ROYAL PINE HOMES – SITE INSTRUCTION

SITE INSTRUCTION NO.3.RP.INTERIORS			
PROJECT:	Hampton Place	LOCATION:	25 Baker Hill Blvd Stouffville, ON
DATE:	Dec 13, 2018	BY:	L. Renzetti

PARTIAL PARTITION PLAN.
DOG WASH

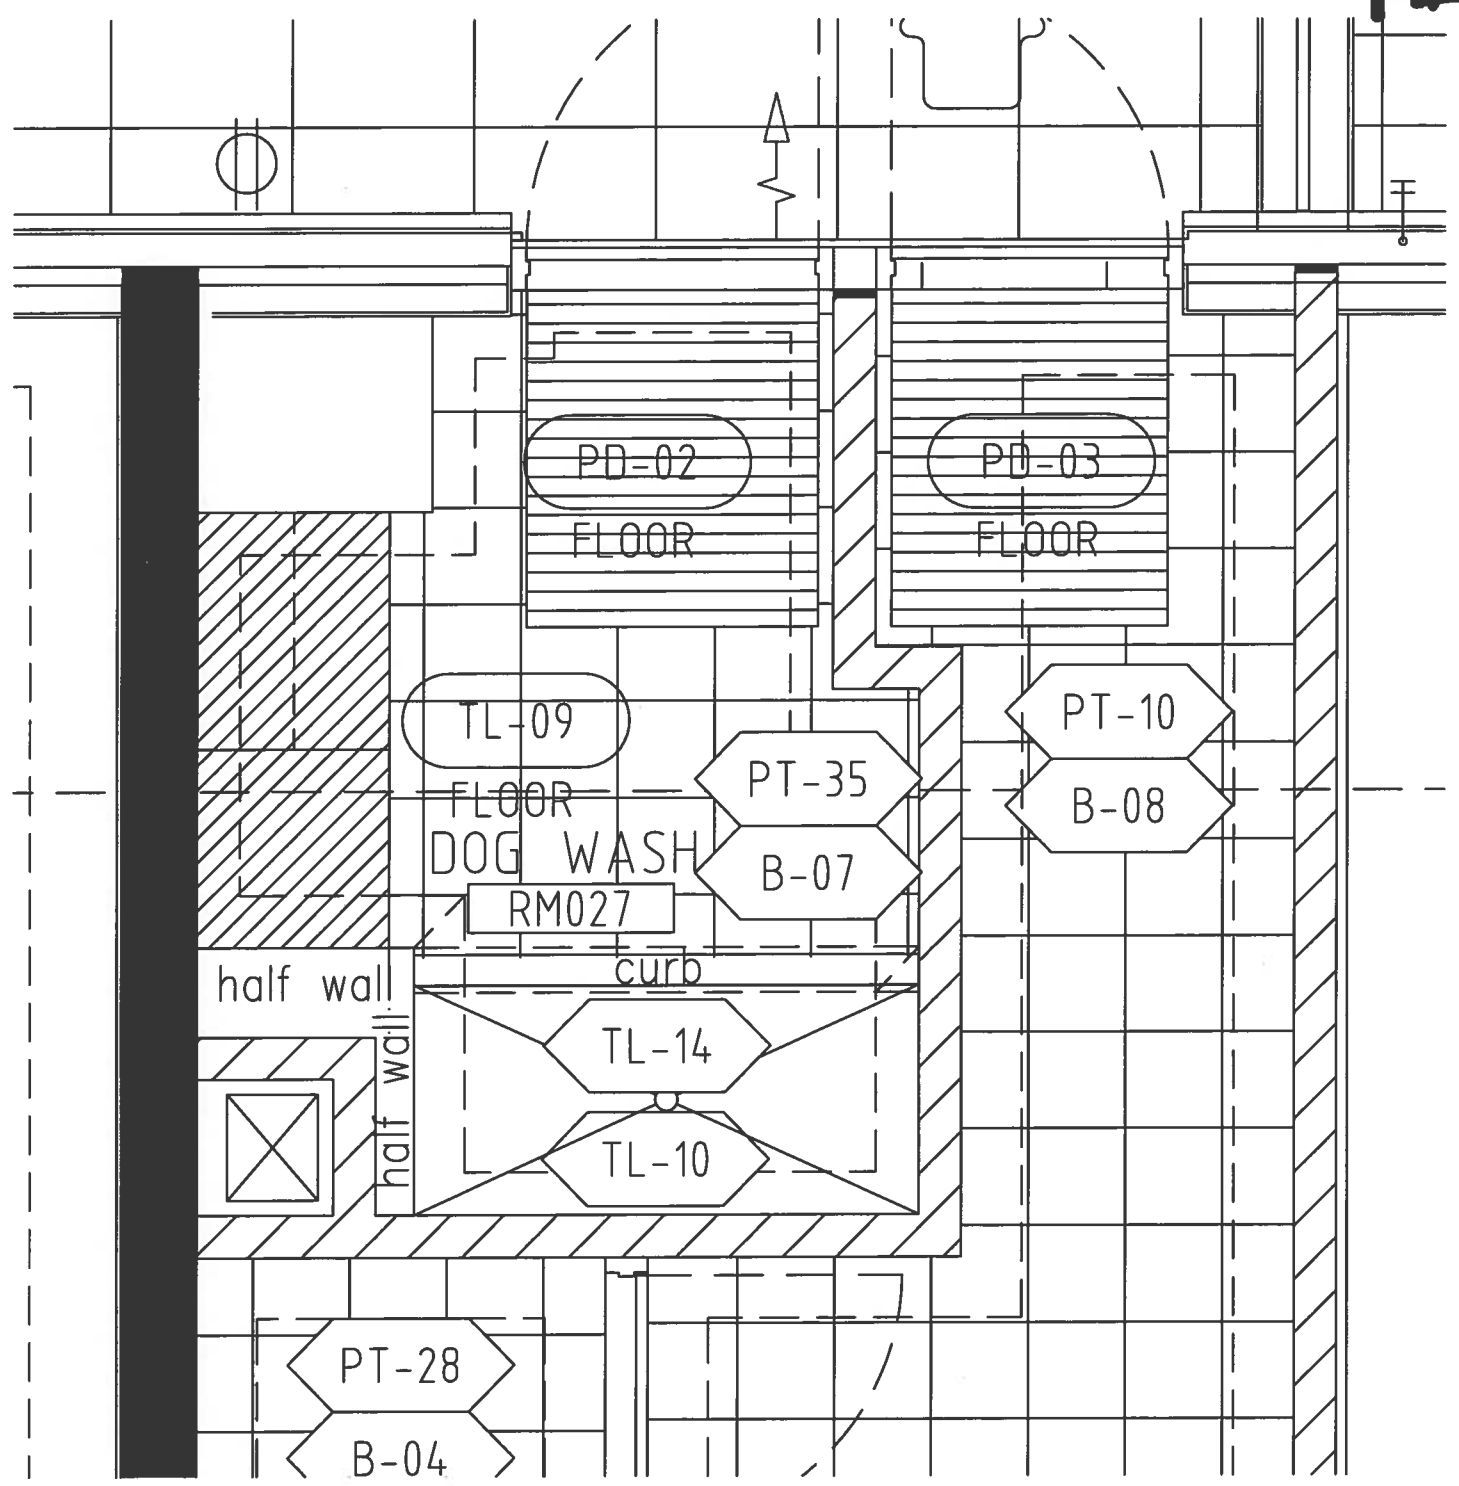
1.18	ID305 Corridor 007 & Stair C	CLARIFICATION: B-04 and B-08 to be Base B-02 Argeus Stone Gray
1.19	FX-12	DELETED. SIZE ON PLAN DIFFERS FROM SPEC: dog wash now tile basin. Refer to attached drawings
	General	CLARIFICATION: Where floor and wall tiles occur in public space, tile contractor to align grout lines when transitioning from floor to walls

1.101	Fitness Room	CHANGE: Millwork cabinet to be located in gymnasium to house rogers boxes
1.102	Dog Wash	CHANGE: Refer to attached plans and elevations for changes to dog wash

1 ELEVATION

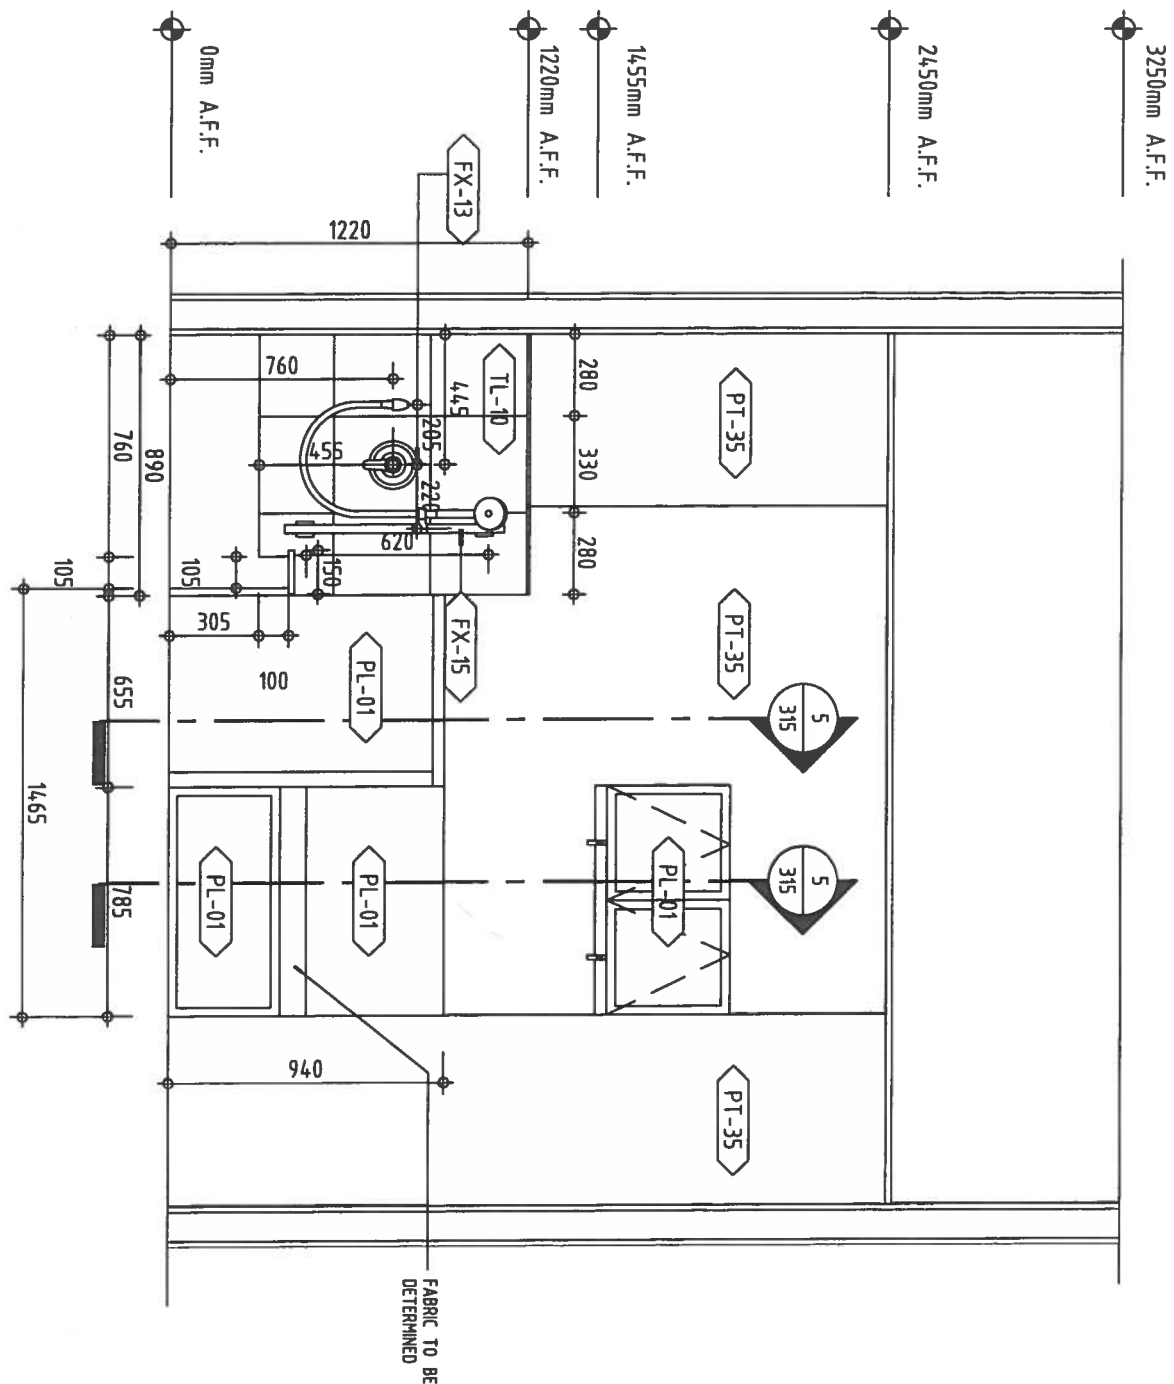
1.20	6/305	CLARIFICATION: Use edge profile sch-01/mtl-03 at top of wall tile, dog wash
1.21	1/315	CLARIFICATION: Dog wash, Section line 5/315 to read 4/315

1.22	1/315	CLARIFICATION (PROTECT TOP OF DRYWALL LEDGE: Dog wash, place tile TL-10 at top of ledge adjacent to wash area.
1.23	2/102 and 3/102	CLARIFICATION: WD-02 to be WD-03. Casing C-02/S-01

5 ELEVATION

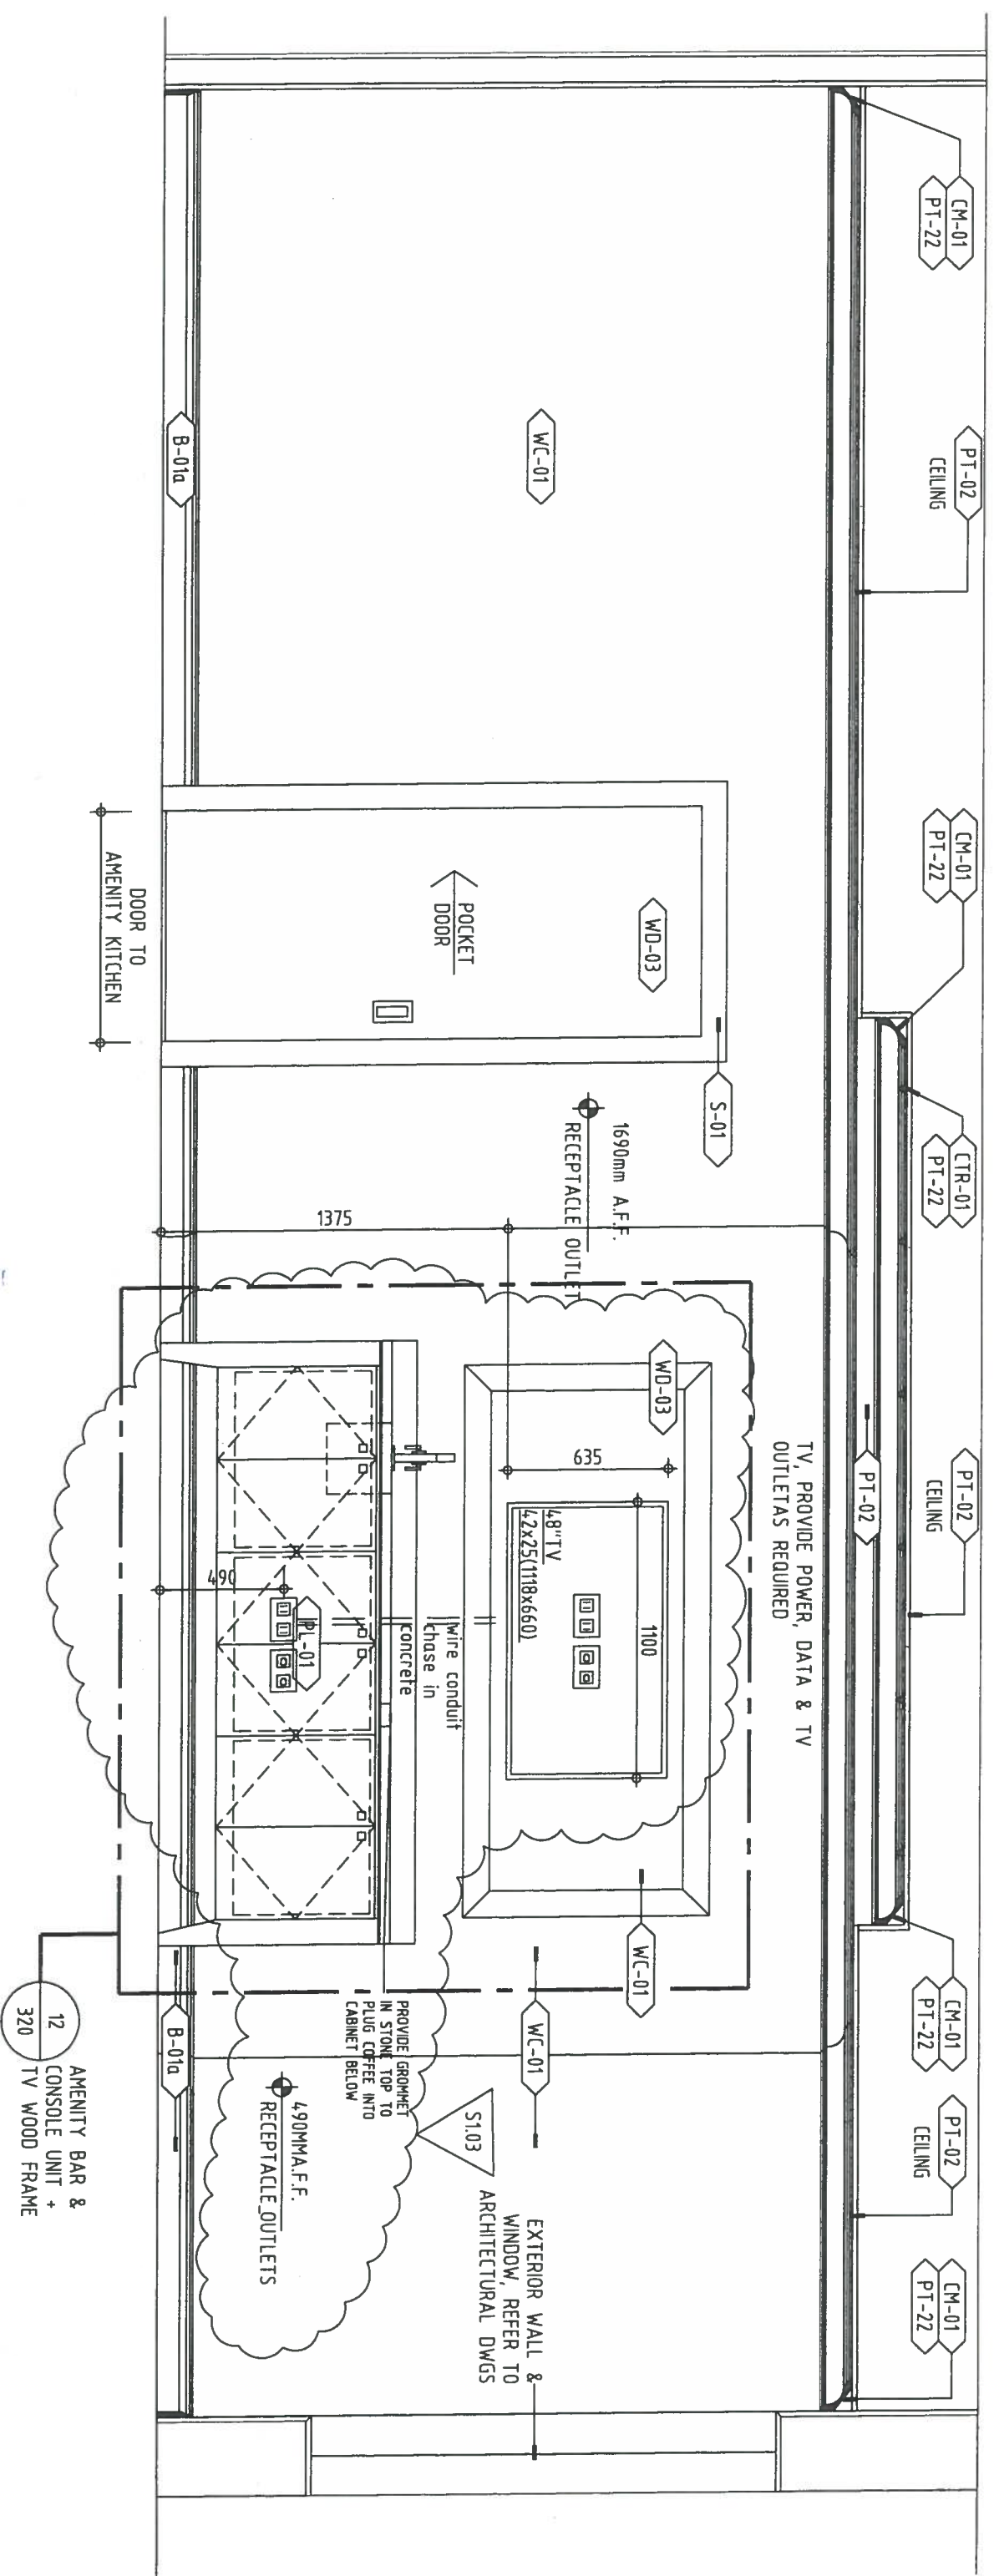
1.88	5/312	CLARIFICATION: Amenity 1 Bar & Console; add grommet to stone counter to allow coffee machine to plug in below. Electrical components moved (with wire chase in concrete) to below counter (millworker to accommodate outlets with cut out behind cabinet). Refer to attached Elevation.

1 ELEVATION

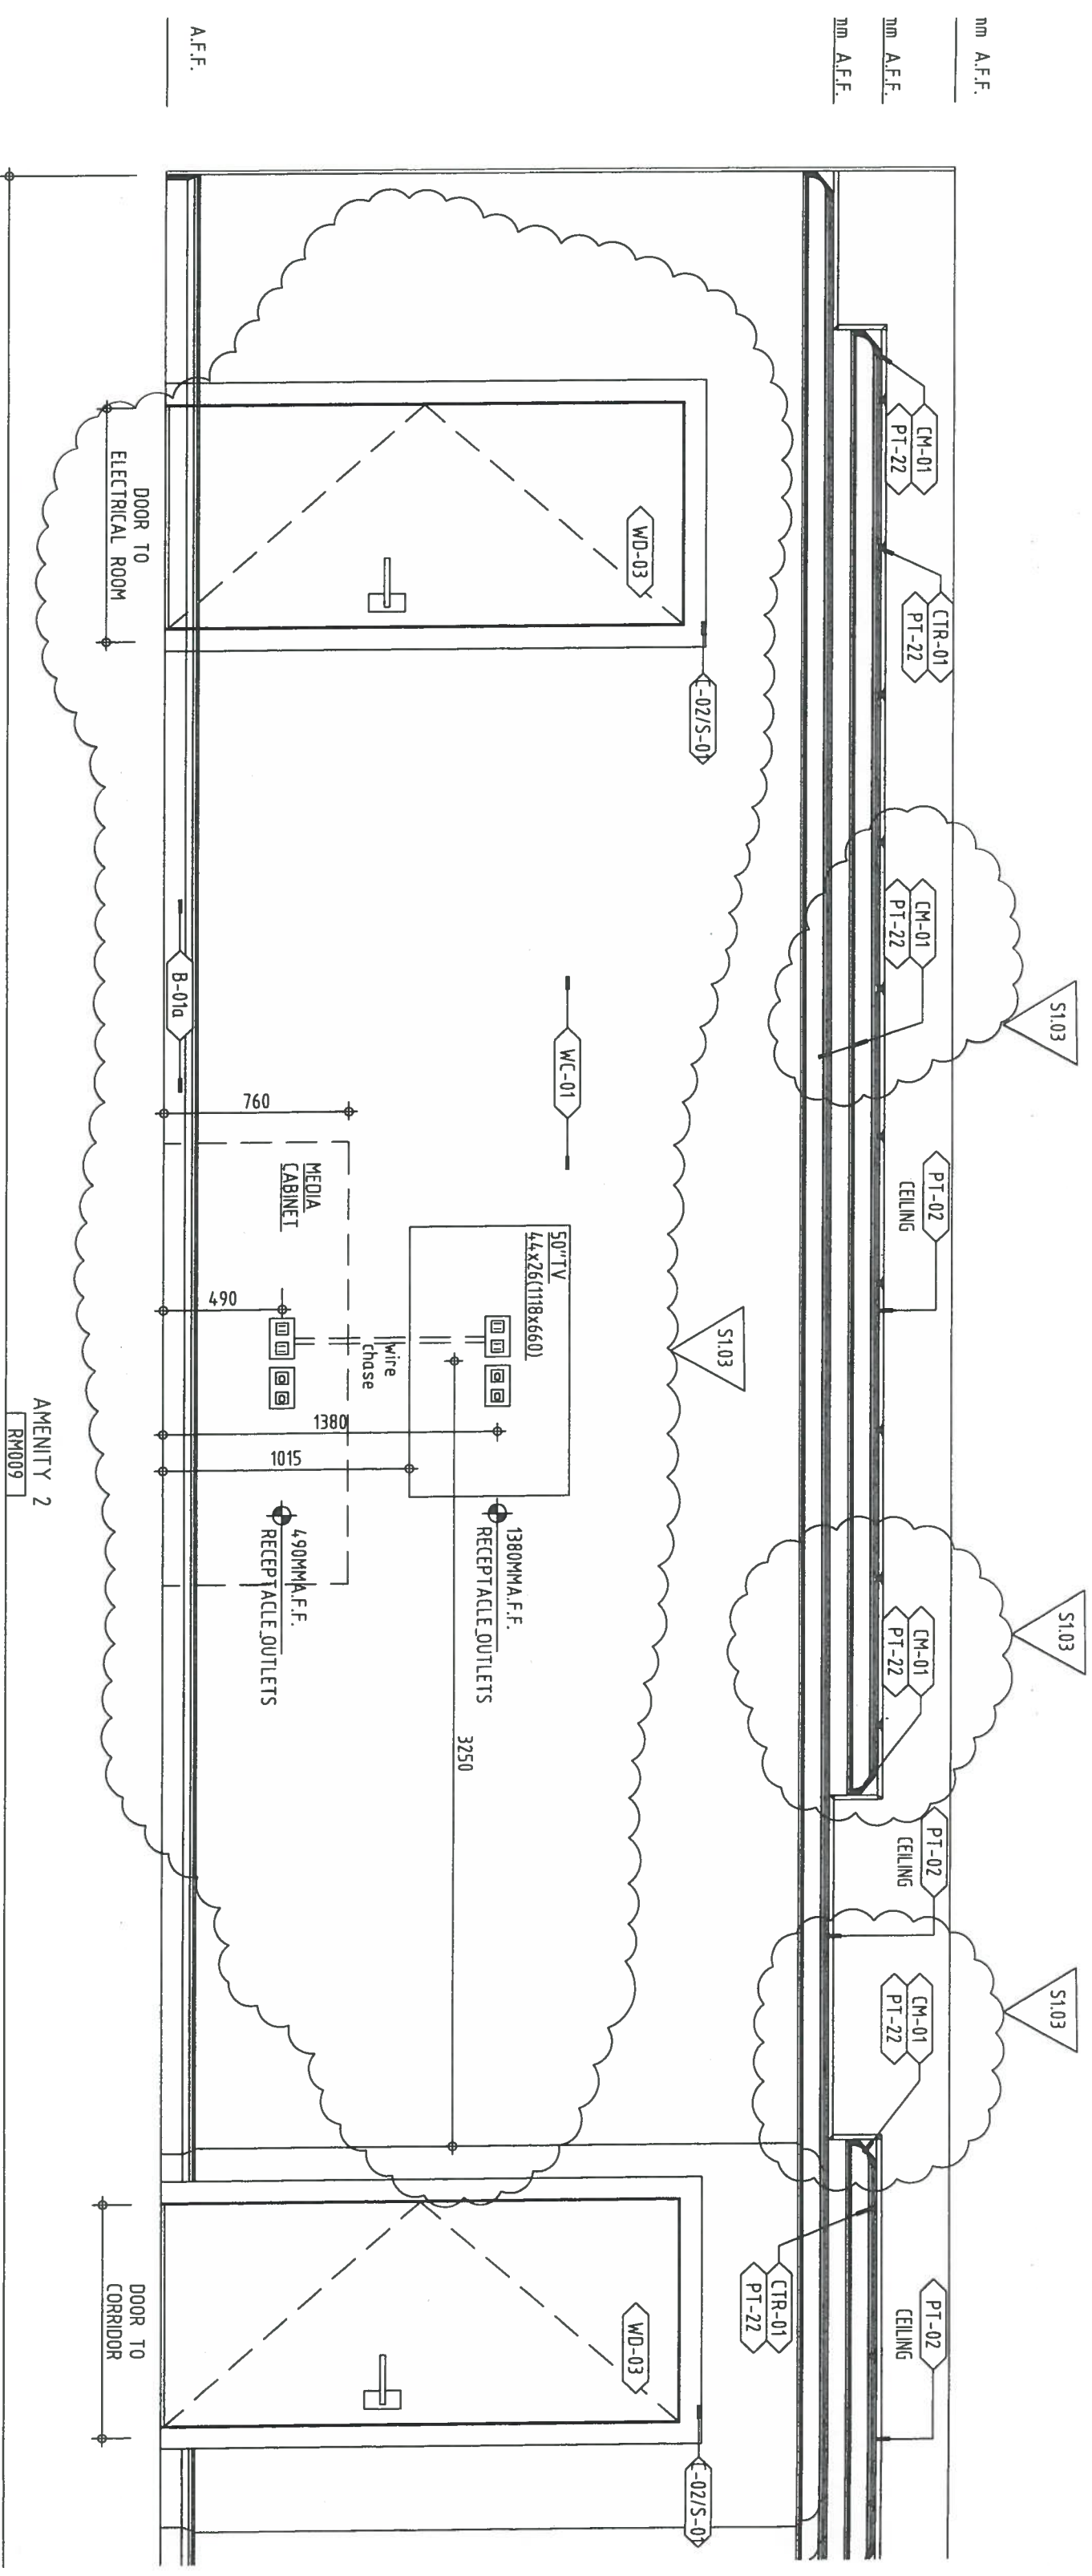
1.41	13/313	CLARIFICATION: Mirror labelled incorrectly. To be FX-17
1.42	14/313	CLARIFICATION: Sink labelled incorrectly. To be FX-02
1.43	Amenity 2/RM 009 ID307 & 1/311	CLARIFICATION: Add television outlet/cable/telephone & data as required as per United Electrical plan. Refer to attached Elevation

1.44	1/311	CLARIFICATION: References to WD-03 at door frames to be C-02 & S-01
1.45	1/311	CLARIFICATION: All CM-01 to be painted PT-22
1.46	4/312	CLARIFICATION: All CM-01 to be painted PT-22
